**DEPARTMENT OF TRANSPORTATION
STATE OF GEORGIA**

SUBJECT APPROVED PROJECT CONCEPT REPORT

SUBJECT: **PROJECT CONCEPT REPORT**
CSHPP-0007-00(641) / Cobb County
Atlanta Rd. Multi-use Trail from Spring Rd./Concord Rd. to Ridge Rd.

Subject:
Atlanta Road Multiuse Trail from
Spring Road/Concord Road to Ridge Road
CSHPP-0007-00(641)
P.I. No. 0007641
Concept Team Meeting

Regional Map

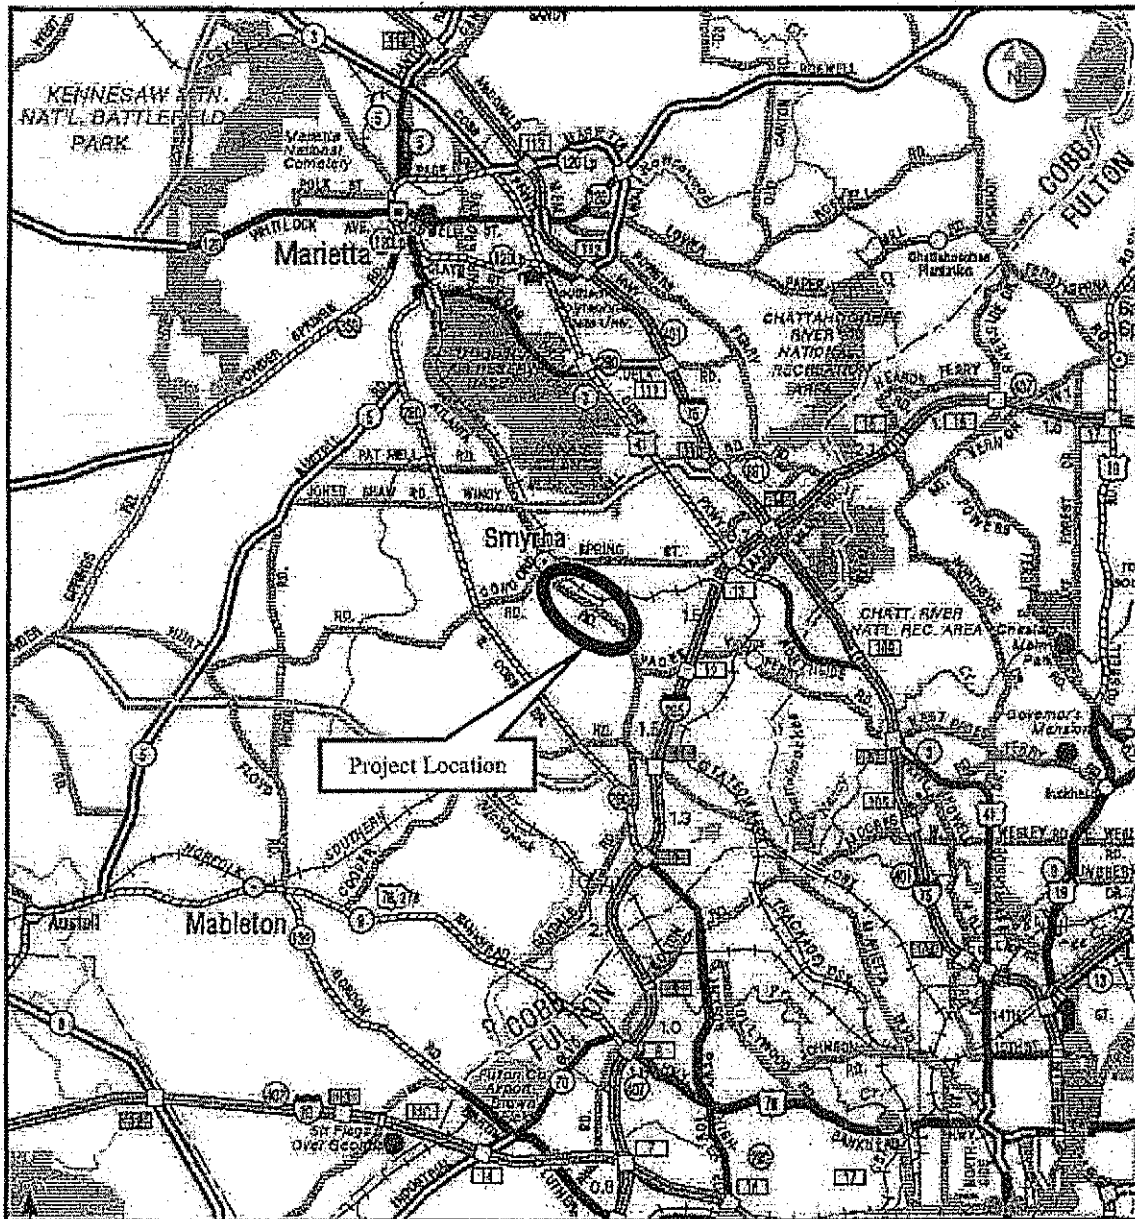
Zoom in regional map to improve readability.
 - c. Page 3

Project Location Sketch

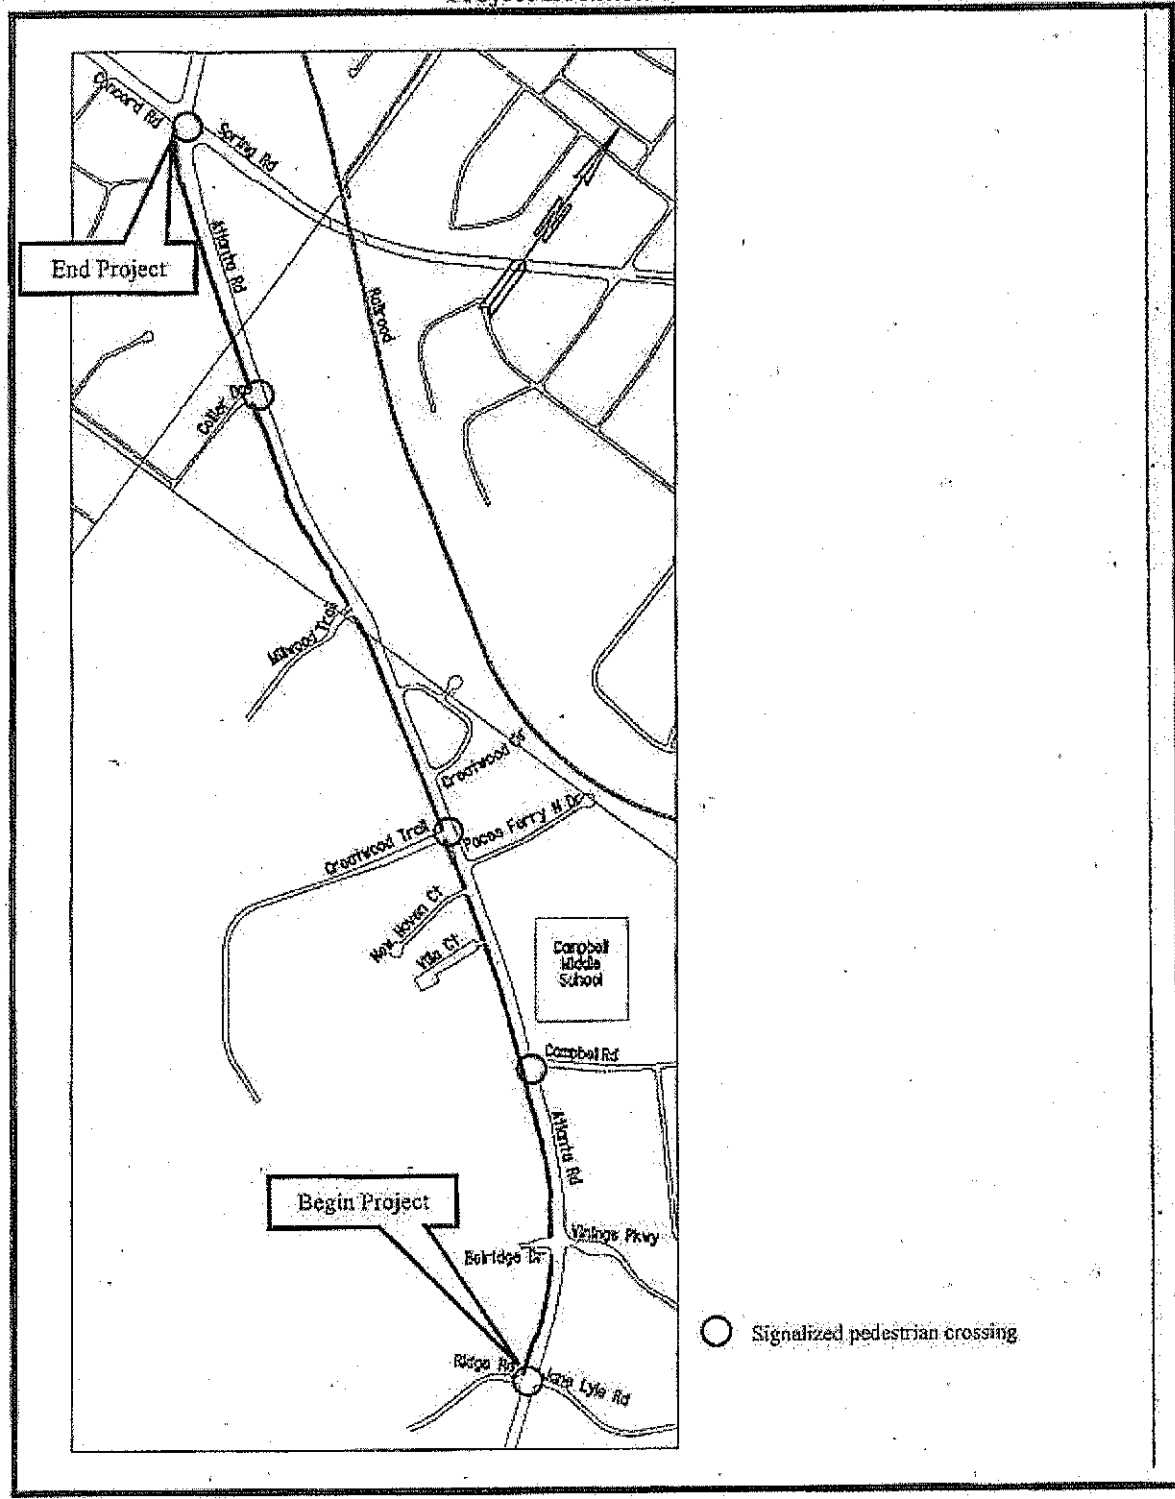
Add symbols to the project location sketch to note all signalized pedestrian crossings.
 - d. Page 4
 1. Add the following to the Need and Purpose statement:
 - a) Provide project details of projects by others that tie into this project.
 - b) Provide the Cobb County Trail Map as an attachment.
 - c) Discuss the signalized pedestrian crossings.
 - d) Discuss the Taylor-Brawner House and associated city park.
 2. Note in the description of the project that the existing pedestrian crossings will be upgraded to current ADA standards.
 3. Revise the state route number from "SR 3" to "None."
 - e. Page 6
 1. Verify the number of parcels.
